Models Affected: RHFE-201FA, RHFE-263FA / FAII, RHFE-431FA / FAII / FAIII / WTA,
RHFE-556FA / FAIII / FTRA / FTRAIII / WTA

When accomplishing any maintenance or repair that involves removing the burner box fitting plate, it is recommended that the burner box plate, packings, screws, and electrode parts be replaced with the Burner Box Fitting Plate Kit, part number 204000018. Use of this kit will make the service procedure much simpler. Details of the kit and part locations are shown below.

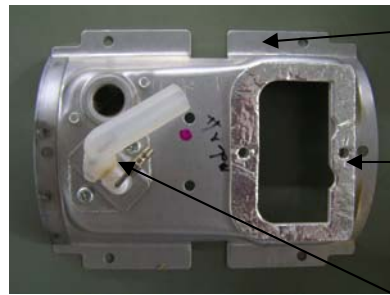
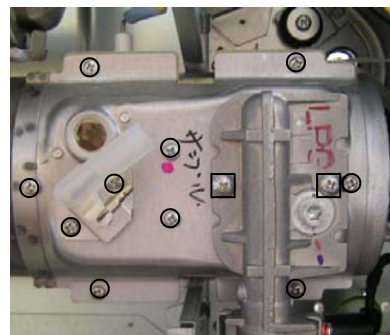
The old packing/gasket must not be re-used. It is necessary to replace this packing/gasket when accessing the burner area to guarantee a seal and prevent the appliance from operating in an unsafe condition. Damage to the appliance may also occur if the old packing/gasket is re-used.
